Preliminary Site Plan and Subdivision Review Applications

90 Main Street Project Yarmouth, Maine

Preliminary 2

DESCRIPTION OF MODIFICATIONS

5. Height of the First Floor less than 2’-6” for Accessibility

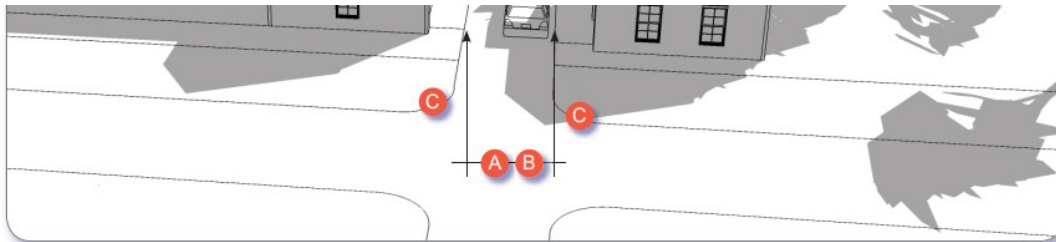
- a. We request the requirement that the first floor be 2’-6” above adjacent grade per CBDC 5.M.1.f. be waived because we are providing accessible access to the two single-family homes.

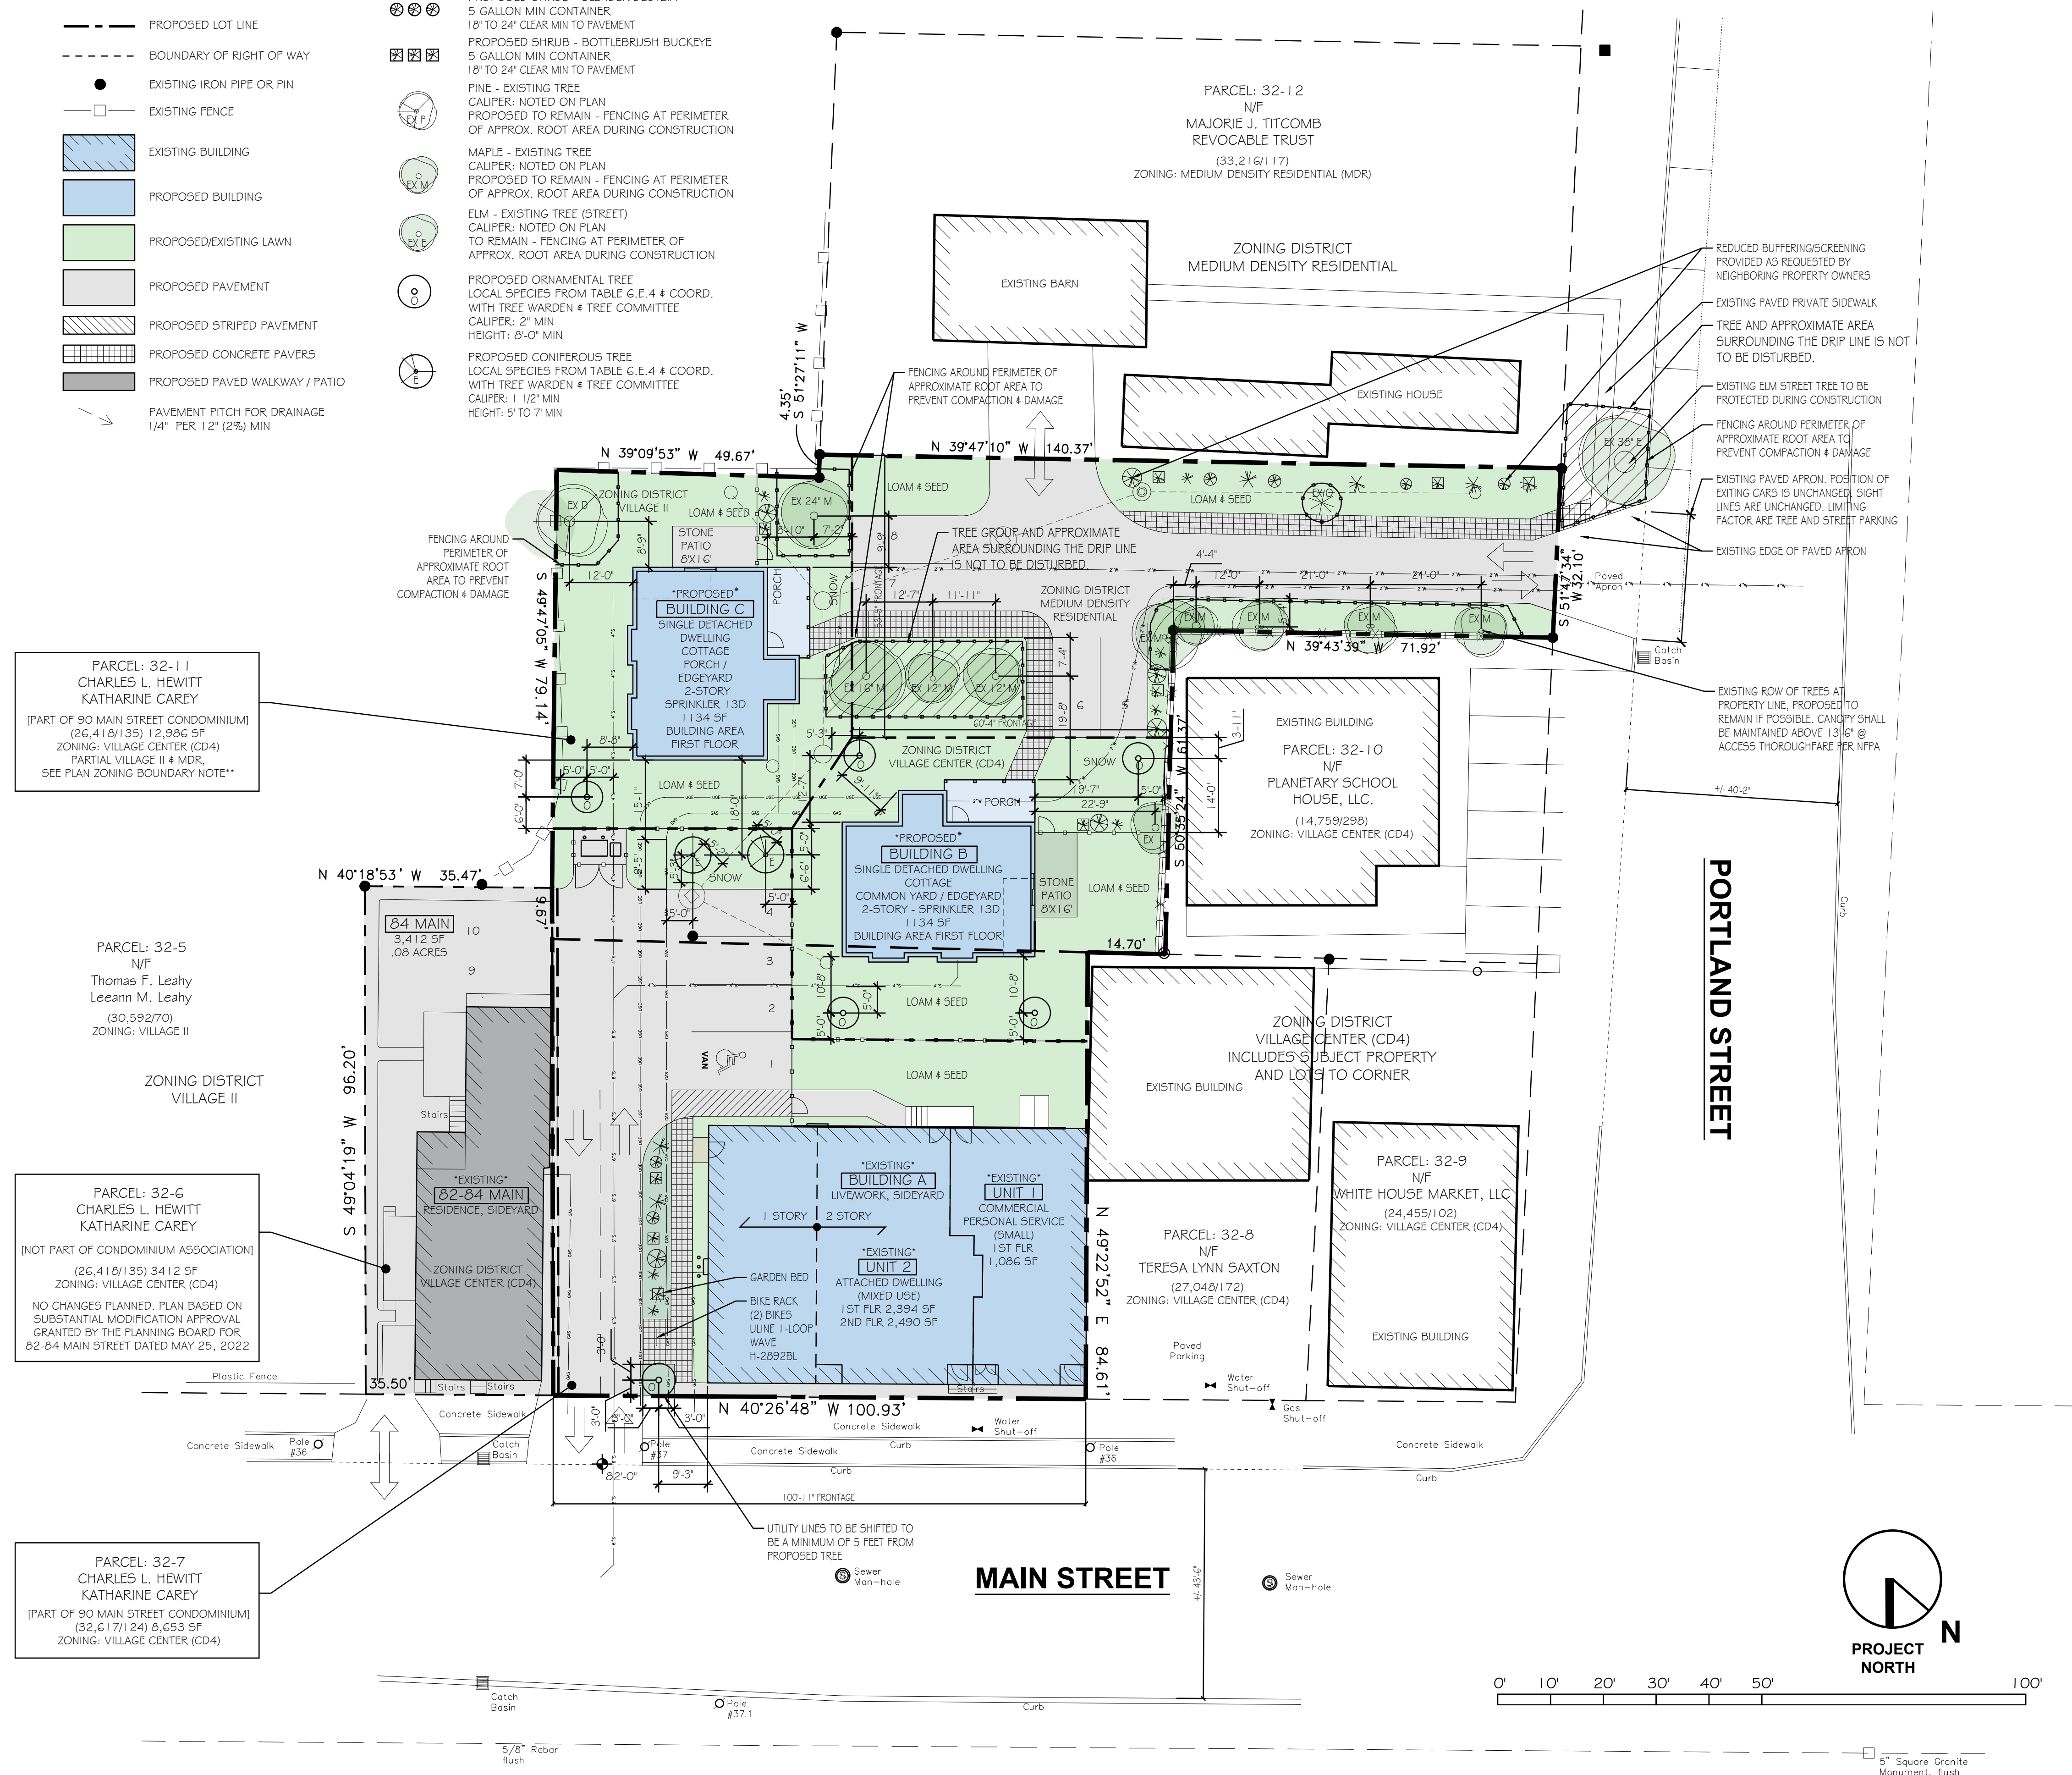
Trees were previously selected from the approved list on Table 6.E.4, it has been brought to our attention the Tree Committee and Tree Warden do not agree with the choices from the list of acceptable plants and have offered to make suggestions after reviewing the latest submitted plan.

Plan added to give more detail to previously submitted information. We are leaving the trees that we wish to save in for the moment while the item of the emergency access is being discussed internally with the city. The proposed trees were shifted to account for the revised stormwater lines. We contacted the Tree Warden about tree species and he indicated that he and the Tree Committee will review the revised plan and make a recommendation. See Exhibit 31 for a Narrative Review of Article 5.N. Landscaping Standards.

SHEET TITLE
BUILDING B
EXTERIOR
ELEVATIONS

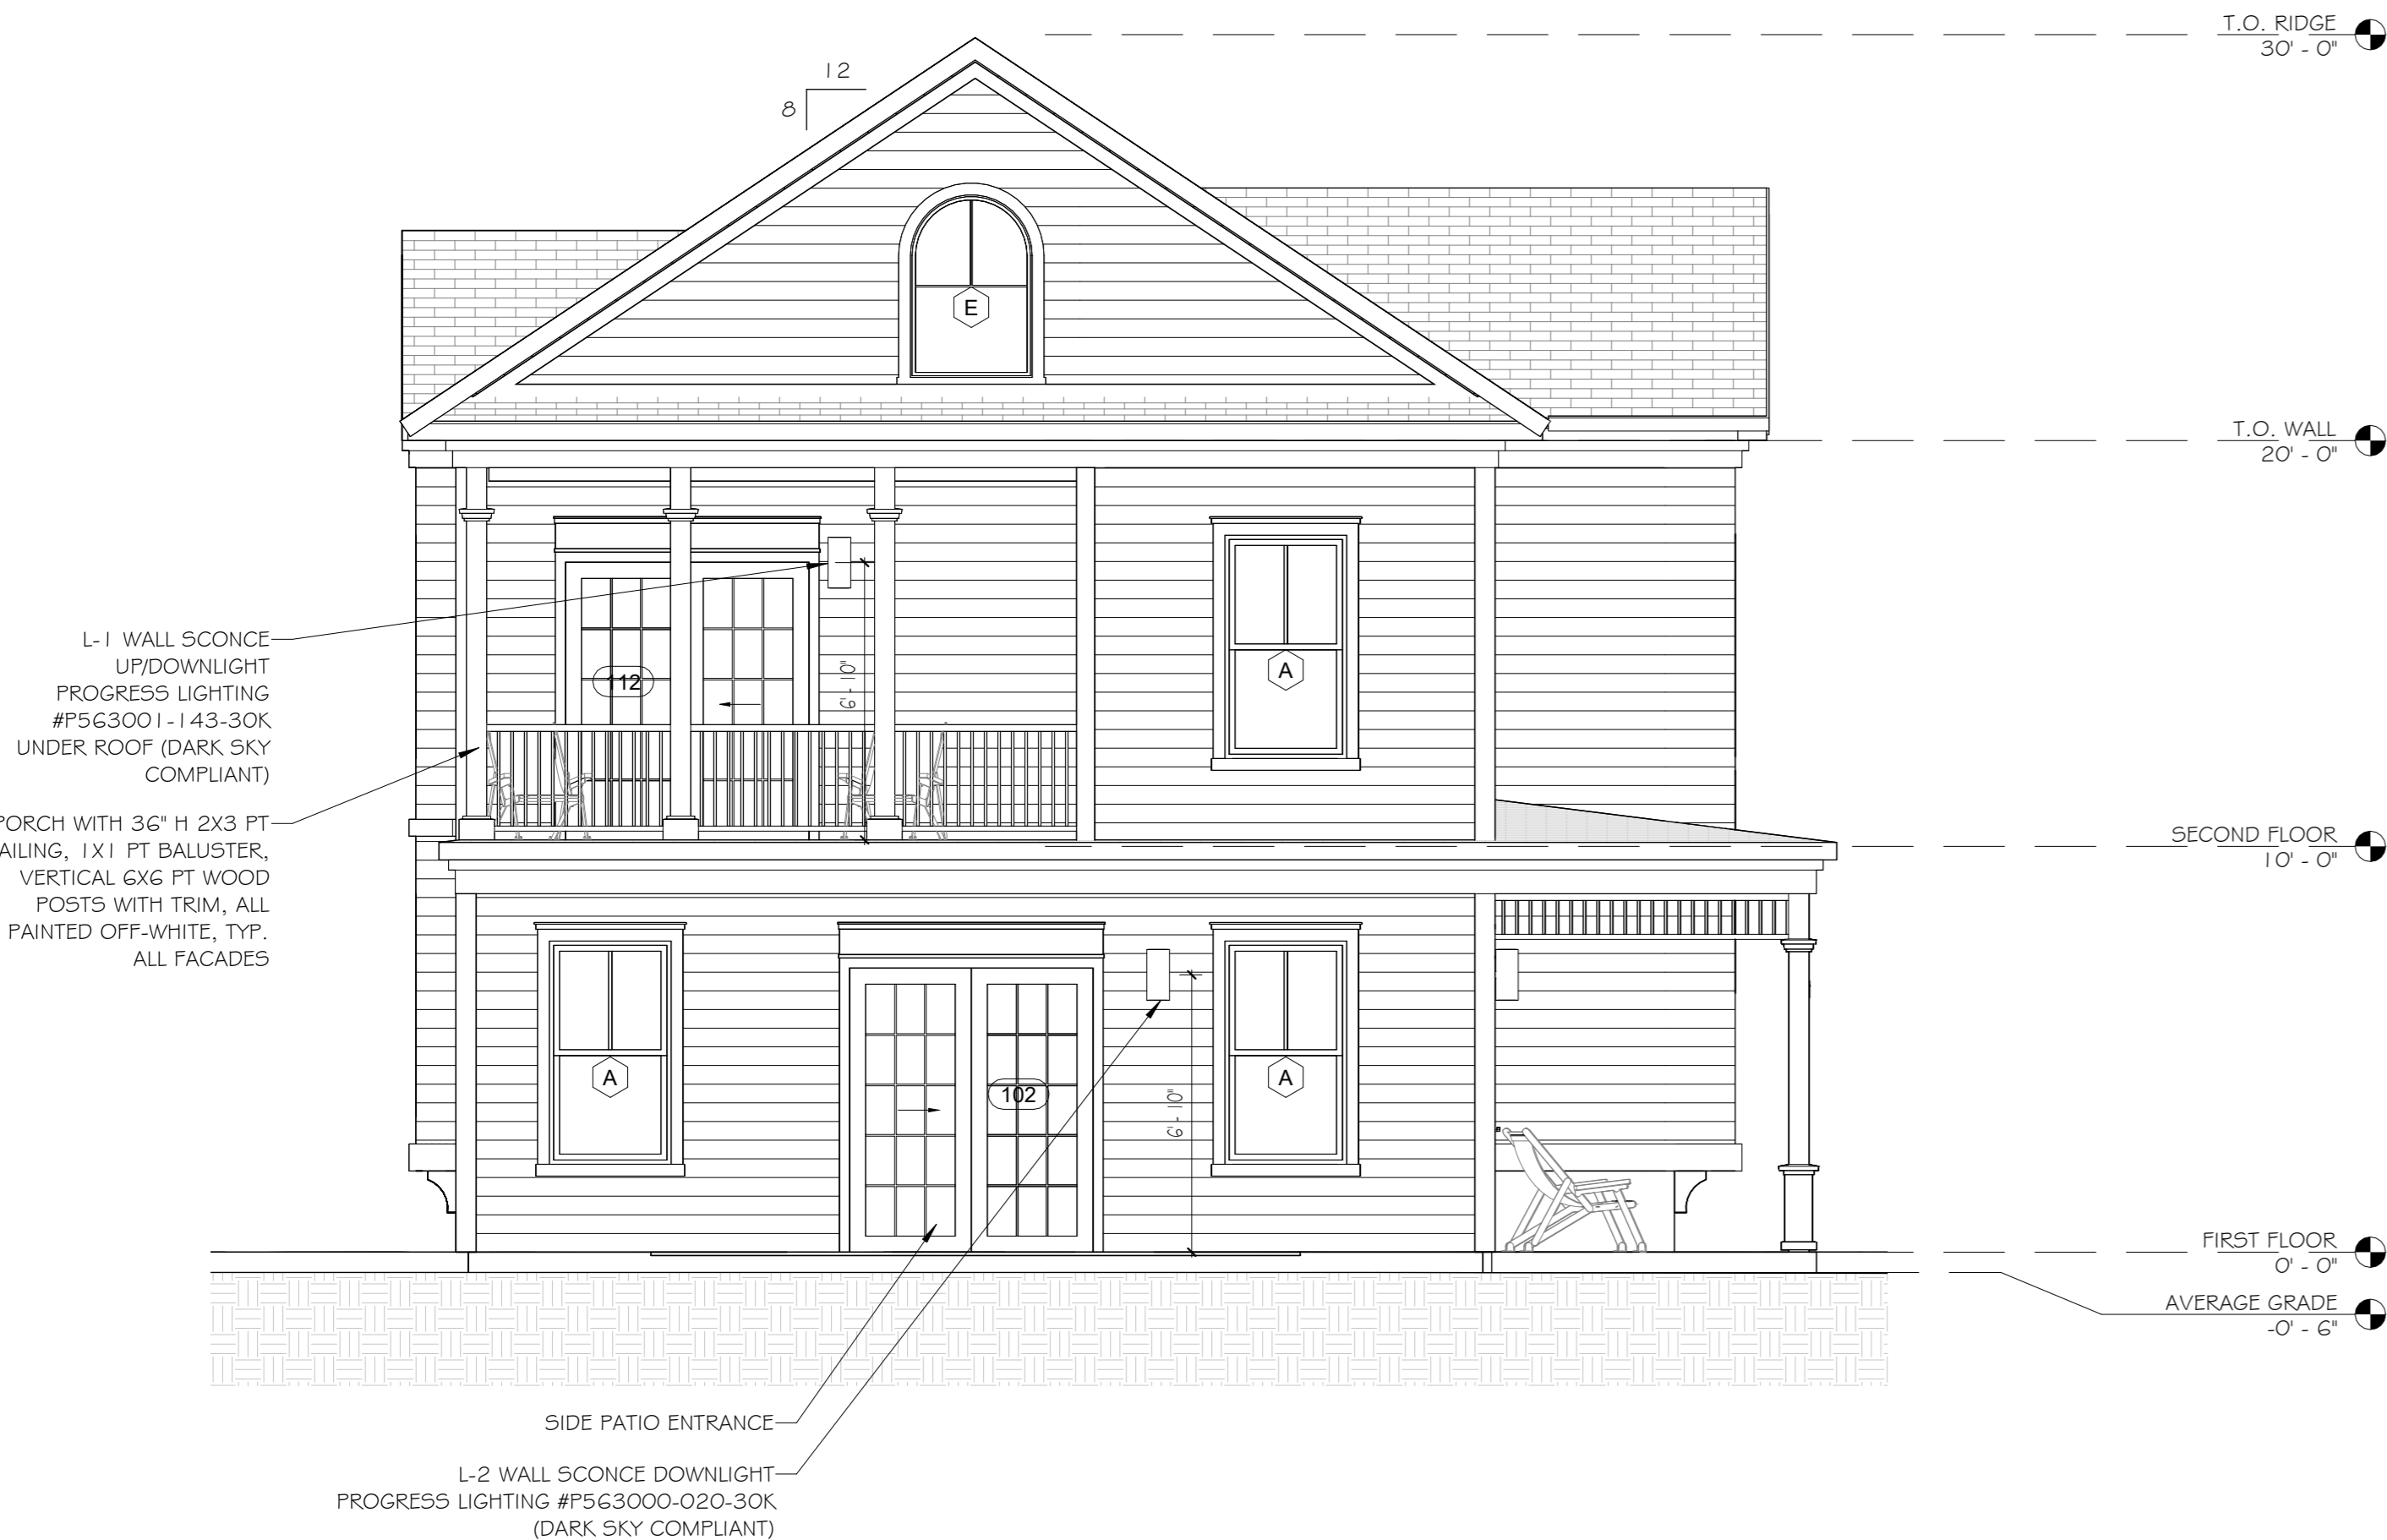
Show wider trim (5/4 x 4 minimum) at the doors and windows, including a historic sill;

Look at dividing the arched attic windows (as labeled on the East and the West Elevations of buildings B and C -the orientation of building C is incorrect on the elevation drawing, it should be north and south) so that they look like the 2/1 double hung windows below, i.e. a divided lite top sash and a single lite bottom sash. This could be done with simulated divided lites on a casement or fixed window. Or consider circular windows, 2/2;

Consider removing the small windows in the small dormers.

Modified, see elevations.

Modified, see elevations.

We looked at this a few different way and found that there is not enough space to separate the windows without making further modifications that are detrimental to the plan, elevation, and/or window proportions. In addition, we do not believe that it improves the façade and feel that a unified window with a 4" horizontal break is the most aesthetically pleasing and appropriate arrangement.

We tried this and found that the dormer felt blank and less appealing on the façade.
